Register Reference: SD22A/0361 Al

**Development:** Demolition of all existing 1-3 storey industrial/commercial structures and small cafe on site totalling c.5. 500sg.m in area: Construction of a 1-5 storey Transitional Care Facility (step-up/step-down) providing 131 bedspaces over partial basement (total floor area c.6, 743sq.m) with central courtyard (c.519sq.m); The basement consists of a sprinkler tank and pump rooms, water tank room, plant room and workshop; Provision of dining and kitchen areas, siting/family rooms, activity rooms, coffee dock, hair salon, oratory, lobbies/reception areas, ancillary offices and staff areas, stores, toilets, shower/changing facilities, ESB substation, generator, switchroom, service yard and waste areas serving the facility; Lobbies, stair/lifts, photovoltaic panels and green roofs throughout; Partial provision of the pocket park identified in the Tallaght LAP (c.1, 286sqm); New vehicular access from First Avenue and egress onto Cookstown Road via a one-way system through the subject site; Entrance signage on the eastern elevation of the proposed facility; All associated site development works, services provision, connection to the water supply

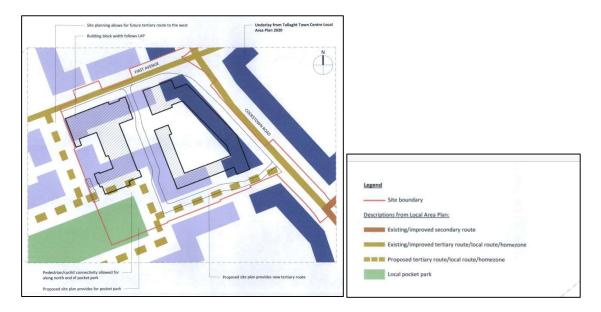
The site layout does not address previous reasons for refusal relating to the dominance of car parking, and there is a concern about the location of car parking along the southern boundary of the site, potentially impacting the development potential of the site to the south, and the delivery of a tertiary route at this location. The applicant is requested to address these concerns with a revised layout, minimising the impact of surface level car parking and protecting the tertiary route through the development.

SDCC Roads Department is satisfied that the parking layout complies with DMURS guidelines with regards to perpendicular parking. However, SDCC Roads Department is concerned that the proposed parking layout does not allow sufficient space for any future route southwards and around the pocket park. This would seriously limit permeability around the park boundary and between neighbouring developments.

The Tallaght LAP has anticipated a Proposed Tertiary Route/Local Route/Homezone linking Cookstown Road to the pocket park with the proposed route continuing around the boundary of the park. The applicant should allow for the future construction of this link when designing the parking layout.

With respect to the dominance of car parking, the refused development proposed a total of 42 no. surface car parking spaces which has been significantly reduced by 24% to 32 no. spaces. The design of on-street parking is in accordance with the guidance set out in DMURS Section 4.4.9 through the following design features:

- Reduced parking rates where densities are high;
- Perpendicular spaces proposed on the internal local street where vehicles volumes and speeds will be low;
- Bays of parking spaces limited to 6 perpendicular spaces with landscaping features provided between them;
- Perpendicular parking limited to on-side of the street in each location provided to avoid dominating the streetscape.

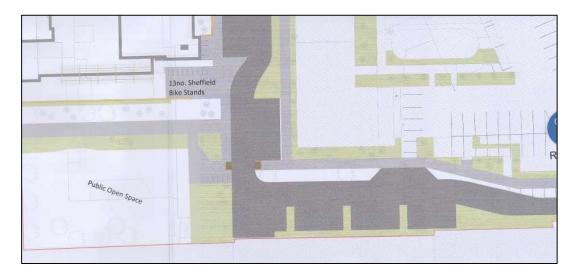
- (a) a layout of not less than 1:200 scale showing a revised internal road layout with a two-way system along with a vehicular link road running along the Northern boundary of the Park.
- (b) a layout of not less than 1:200 scale showing a Pedestrian Crossing with tactile paving and dropped kerb located between southern internal footpath and the Pocket Park.

- 10. (a) The applicant has not provided a two-way system through the development along with a vehicular link road running along the Northern boundary of the Park. This would inhibit vehicular and cyclist movement between Cookstown Road and the public park, and would seriously limit permeability around the park boundary and between neighbouring developments.
- 10. (b) SDCC Roads Department is satisfied with the applicant's provision of the pedestrian crossing.

In response to Item No. 10a, the single carriageway has been designed in accordance with best practice and compliance with DMURS. The overall layout and circulation routes reduce car dominance, promote traffic safety

and prioritise pedestrian and cyclist activity. As such, car parking is limited and restricted to a single carriageway through the site.

In response to Item No. 10b, we refer to Drawing No. B981-OCSC-XX-XX-DR- C-0111 (Proposed Road Layout) prepared by OCSC. The pedestrian route leading from Cookstown Road across the internal road to the pocket park will comprise a footpath south of Block B (proposed under separate LRD proposal) crossing the internal road via a level crossing and continuing through the pocket pack.

The proposed one way vehicular route through the site has been incorporated to reduce the dominance of road space through the development site and minimise unnecessary vehicular movements through the site, giving priority to pedestrians. Providing a 2 way road through the site would have a detrimental impact on the development layout and reduce space available for landscaping and safe pedestrian areas, whilst also reducing the area available for buildings on the site which would lead to necessary reductions in scale, efficiencies and viability of the development. There is no tangible and obvious benefit to the provision of a two-way road. With respect to the accessibility of the public park, it is noted that the section in the southeast corner of the development is just one portion of an overall park to be development in conjunction with the adjacent sites. This will provide multiples access routes to the park area facilitating access from all directions.
